SPECIAL PERMIT SUBMISSION

815 Somerville Ave

PROPOSED CONVERSION

VOLUME III - APPENDICES

FIGURE 6. Rooftop barrier configuration (proposed acoustic walls shown in red, architectural roof screen shown in orange)

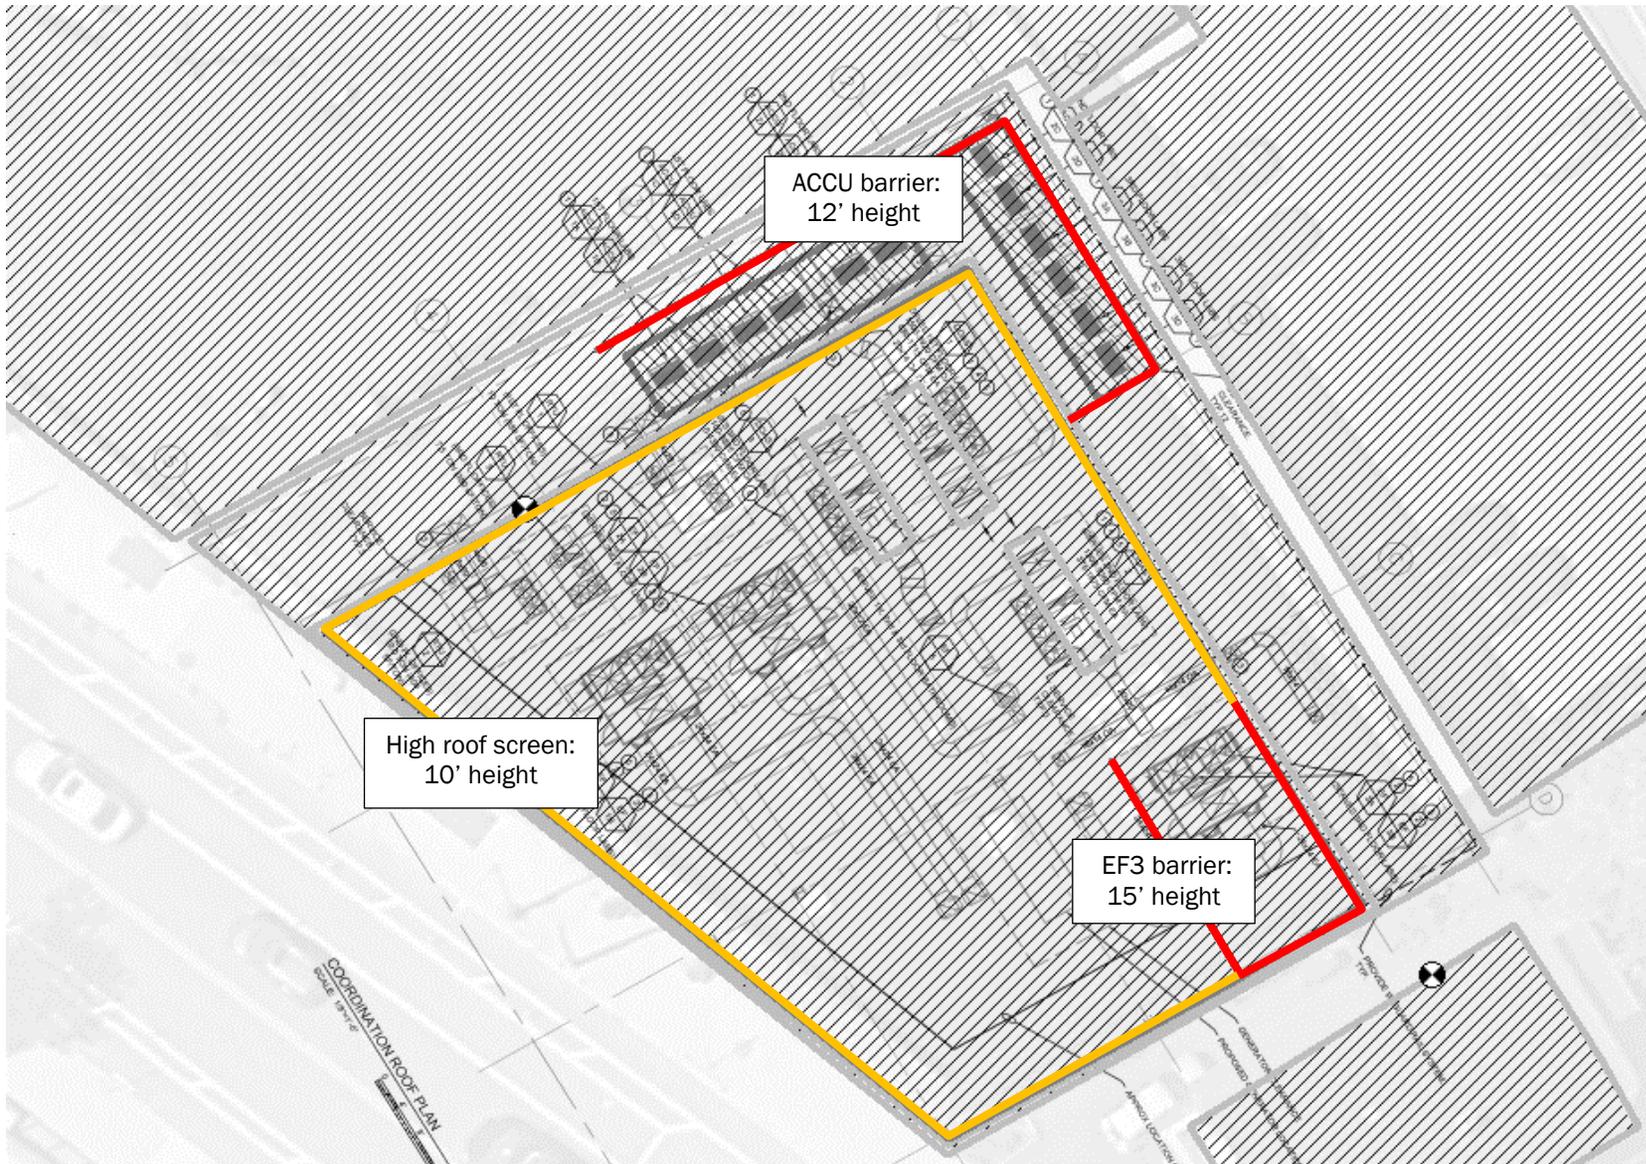
Our model assumes that the currently proposed 10’ tall screen wall on the high roof will remain, as shown in FIGURE 6. There is no benefit to a sound-absorptive face for this barrier.

We do not expect that the 4’ Strobic discharge attenuator alone will be sufficient to reduce EF-3 sound to project design goals. In this case, we recommend that you increase the height of the screen wall around EF-3 to 15’, as shown in FIGURE 6. Note also the recommended barrier leg running north-south, which decreases community sound levels directly to the south by about 1 – 2 dBA. There is no benefit to a sound-absorptive face for this barrier.

Rather, we recommend that you construct a system of 12’ tall sound barrier walls around the ACCUs, also detailed in FIGURE 6. The side facing the equipment should have a sound-absorptive treatment.

In the cases described above, we understand that a solid, non-louvered wall can achieve the equipment airflow requirements. In this case, barrier systems should be selected with panels achieving about STC-30 or 4 lbs/sq ft surface weight. An undercut at the bottom of the barrier up to 12” is acceptable to facilitate the clearing of accumulated snow.
